**CITY OF LA MARQUE
CITY COUNCIL
SPECIAL AGENDA
of
February 3, 2025**

5.III. Change Order #6: Sanitary Sewer Rehabilitation

Re: Texas General Land Office (GLO)
CLO Contract No. 22-083-003-D208
Letter of Justification for Change Order No. 6
Adico Project No. 20100-17

DUROUX ROAD
STA 0+00 TO 10+00

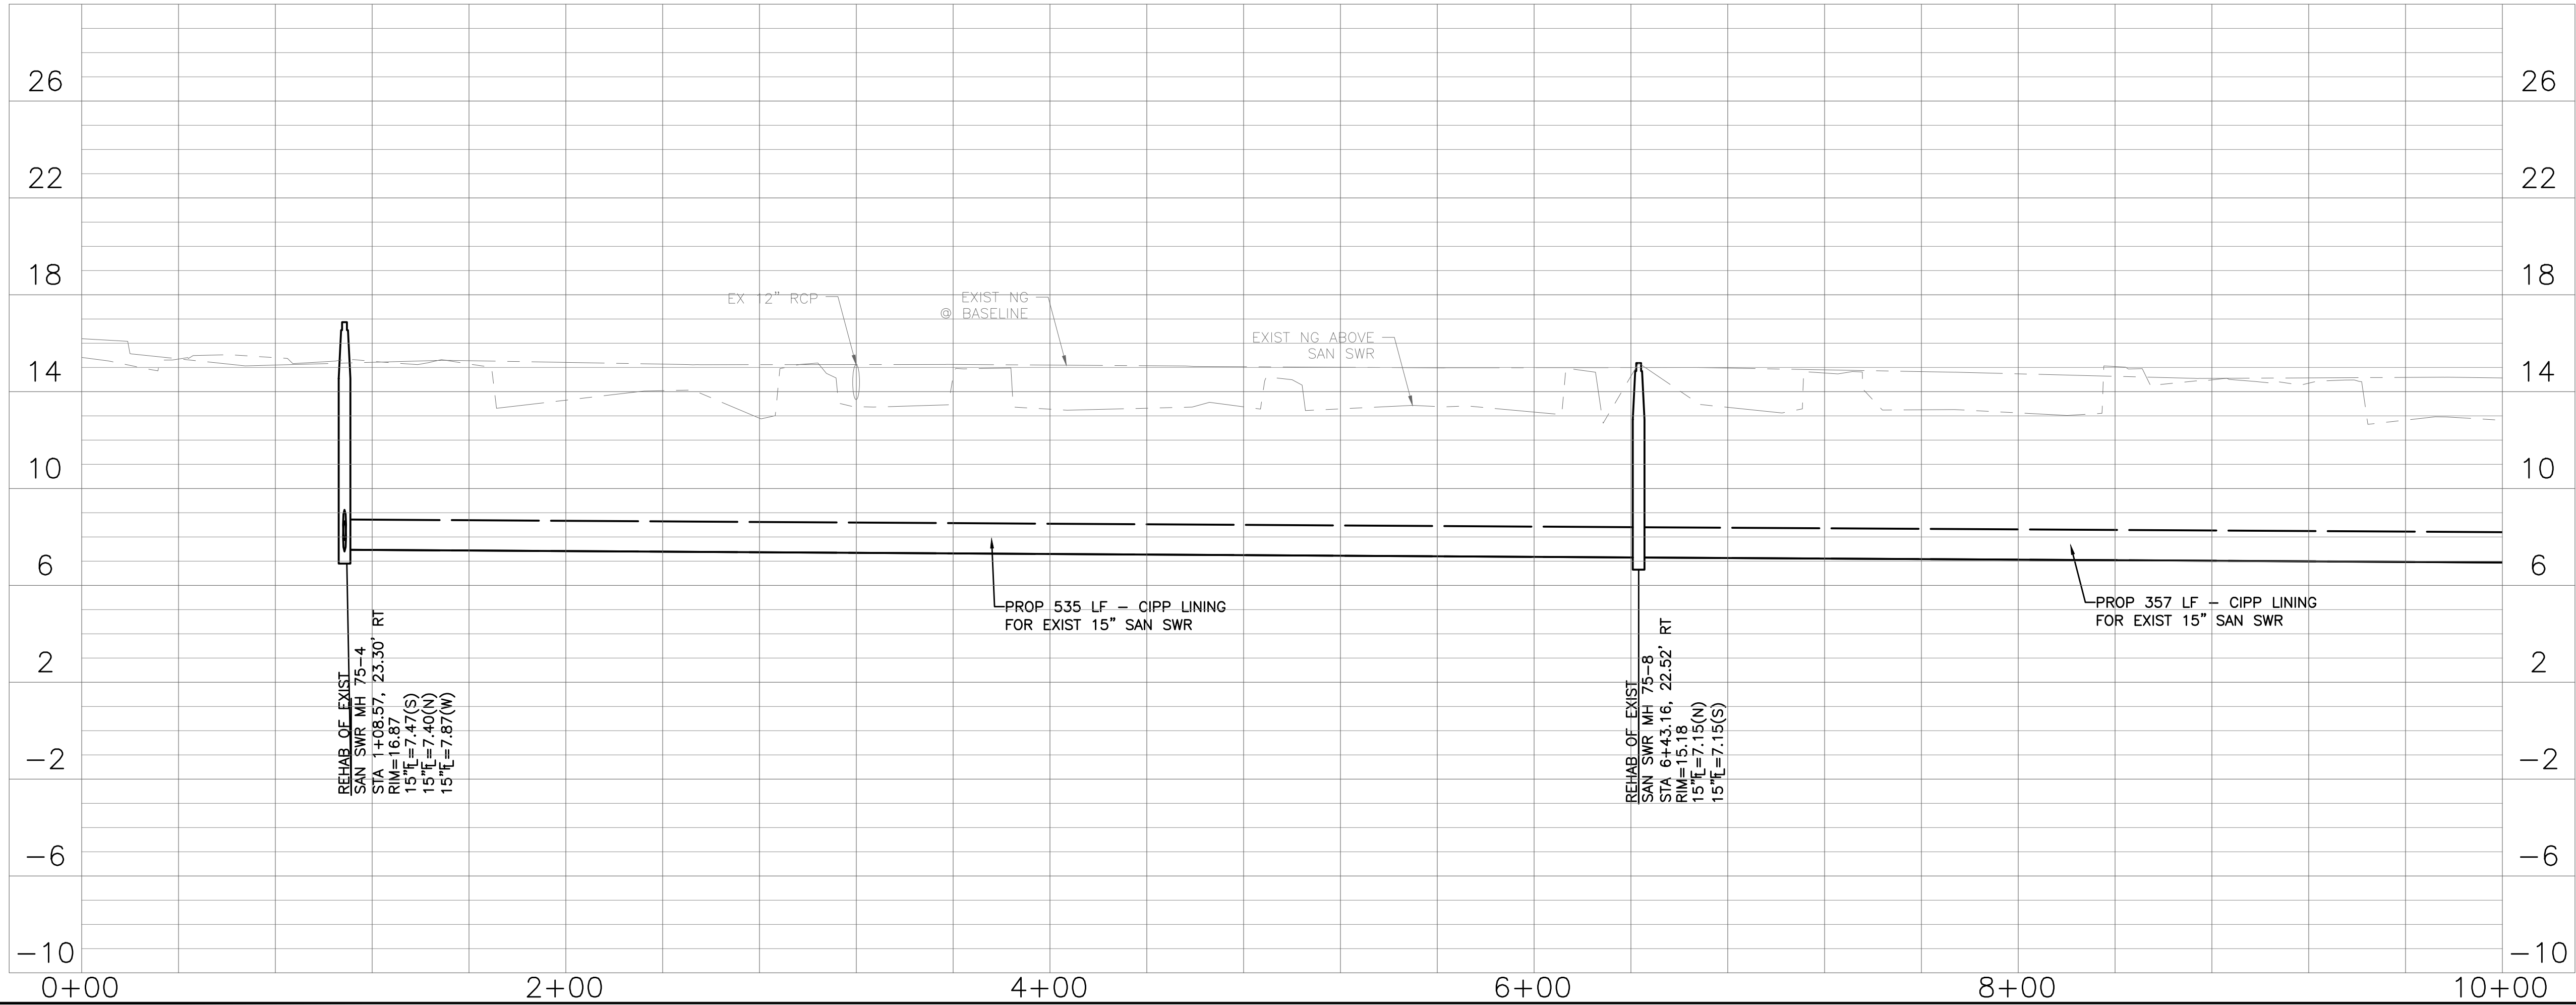
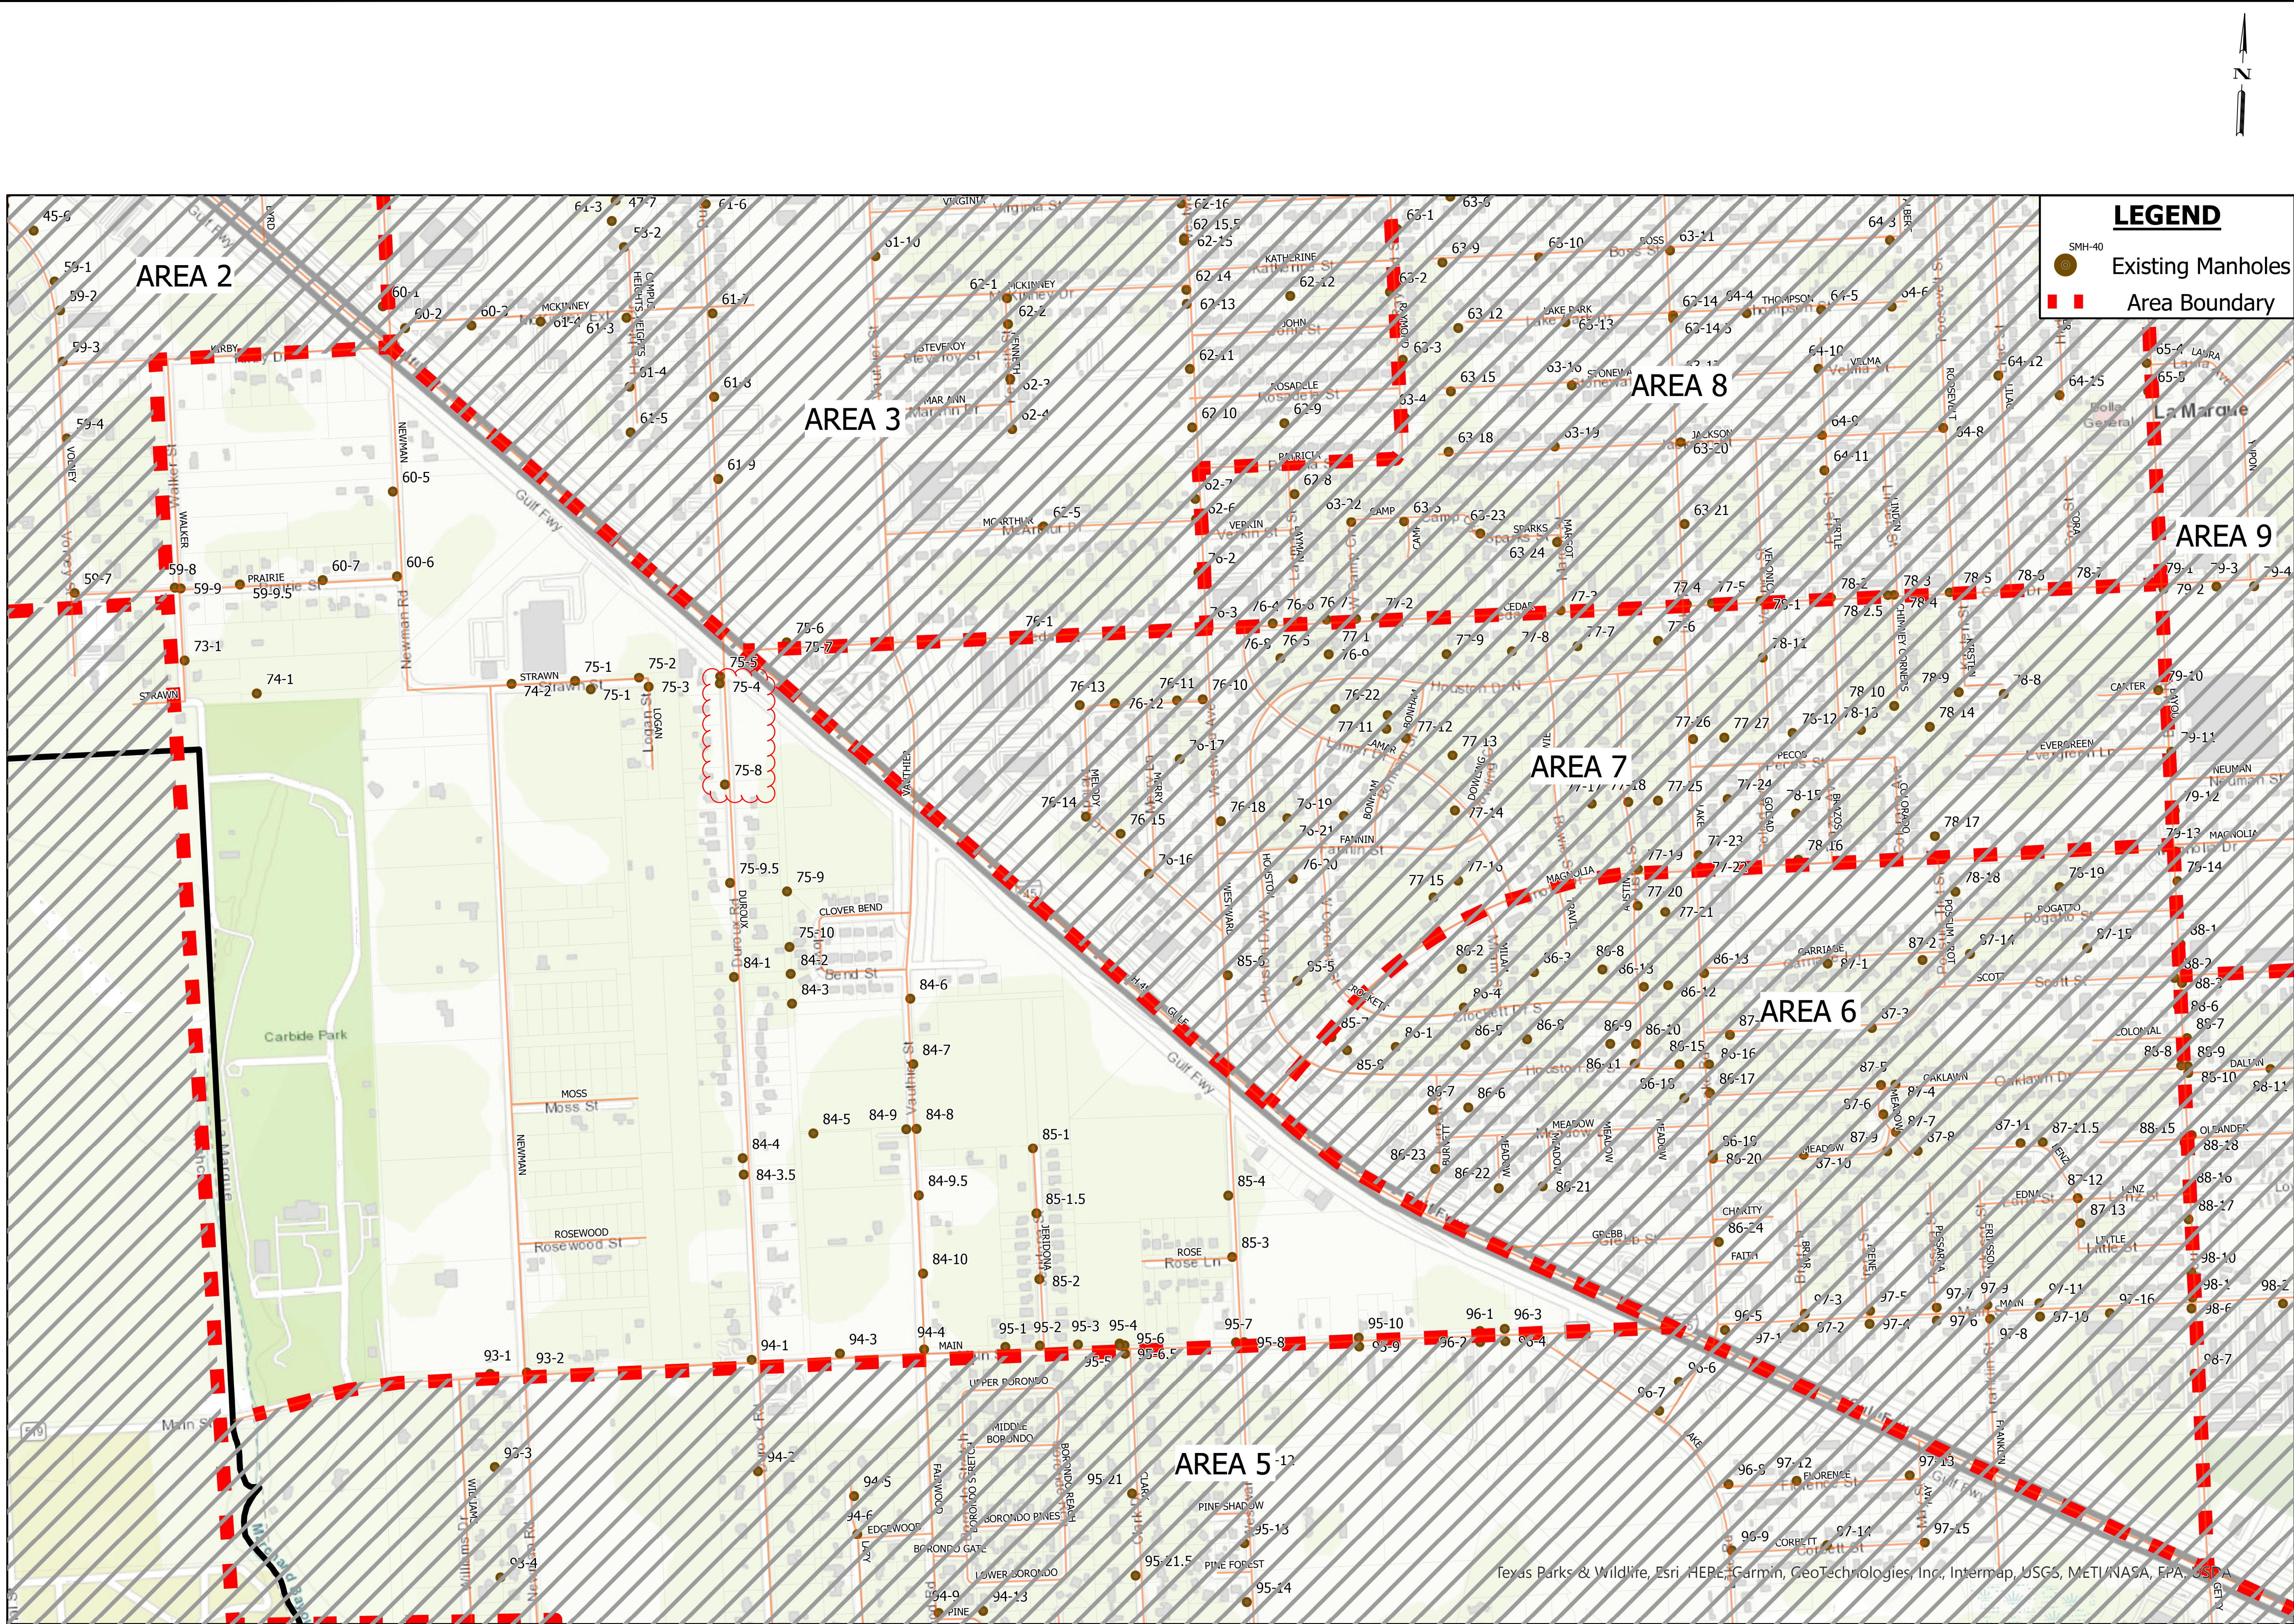
This change order was initiated as a result of conditions encountered during the construction phase. Southern Trenchless conducted an assessment of the existing sewer system near Manhole 75-4 and observed that the boot coupler at pipe locations adjacent to this manhole had disconnected, resulting in a pipe offset.

Southern Trenchless has been requested to provide a Change Order for repairs to found pipe offset due to disconnection of boot coupler at pipe locations adjacent to MH 75-4 in lieu of CIPP lining the entire pipe sections. The following is a price to install external pipe repairs:

Item No.	Description of Changes: Quantities, Units, Unit Prices, Change in Completion Schedule etc.	Decrease in Contract Price	Increase in Contract Price
ITEM INCREASED:			
C07-1	15" Sanitary Sewer Pipe Point Repair (Section 2)		\$ 18,000.00
C07-2	Rehab Manhole with 13' FRP Insert (MH 75-4) (Section 2)		\$ 17,000.00
C07-3	Furnish and Install Manhole Lid (Including Inflow Protector) (Section 2)		\$ 3,200.00
